SERVICE BULLETIN

FUJI HEAVY INDUSTRIES LTD.

NO : FAS-024A
DATE : July 30, 1970
REV: "A", June 26, 1972

1. SUBJECT : Connection Change of Flap Torque Tube and Arm.
2. AIRCRAFT AFFECTED : FA-200 Series Aircraft, S/N 12 thru S/N 101.
3. PRIORITY : Essential.
4. REASON : To prevent bolt hole deformation by installing bushings since there have been instances reported whereby bolt hole through the flap torque tube and arm have been deformed.
5. DESCRIPTION : It is recommended that the bolt through holes be enlarged and bushings installed in place.
6. ACCOMPLISHMENT : At the next 1,000 hours inspection, when radial play is noted between the bolts and the mating thru holes.
7. APPROVAL : JCAB Approval (NO-TOKYO-047) June 15, 1972.
8. PARTS REQUIRED : The following parts are required to perform the modification:

FIGURE 2. DETAIL OF SPECIAL DRIVER

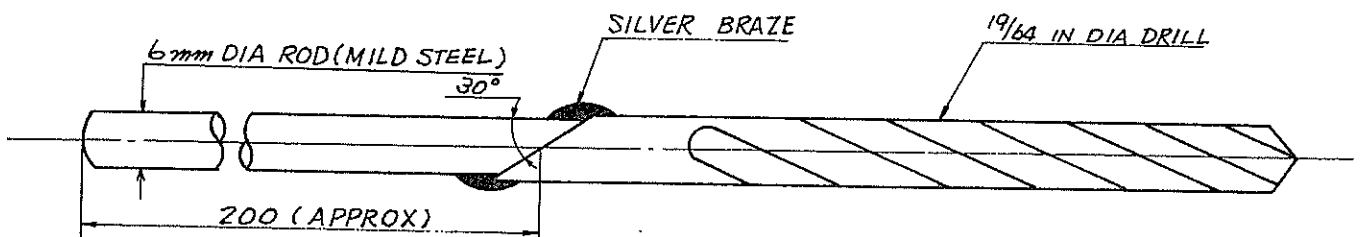
9. SPECIAL TOOL : Special drill (See figure 2).
10. WEIGHT AND BALANCE : Negligible.
11. REFERENCE : Not applicable.
12. MANHOUR REQUIRED : 4.0 manhours required.
